Access Compliance Report

(Curb Ramps)

Intersection ID: 6473	Main Street: MINERAL_SPRINGS_RD	Cross Street: N_GRAHAM_ST	Location: S
ADA ID: 1378FD54E245	Ramp Type: Para	Initial Pass/Fail: Fail	Overall Compliance: No
Codes/Mitigation Info/Possible Solution		Field Measurements/Component Compliance	
Severity Score: 16.25

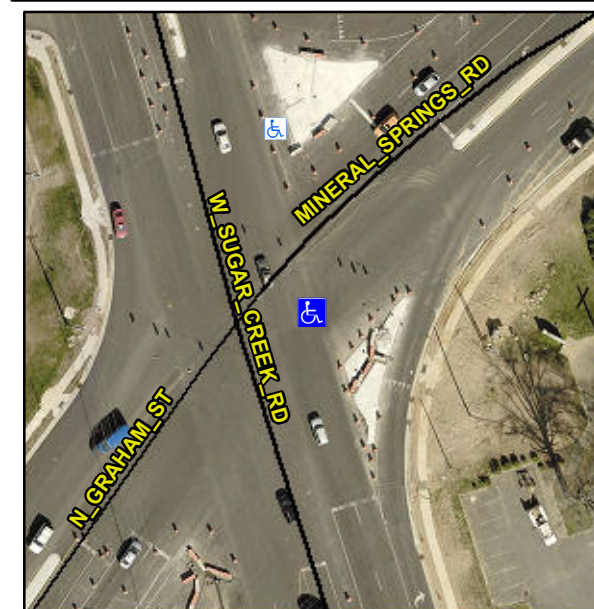
Surveyor Notes:

LT RP < 5%

PROW/ADA:

R304.5.3, R302.7

Possible Solutions:

Remove & Replace Entire Ramp.
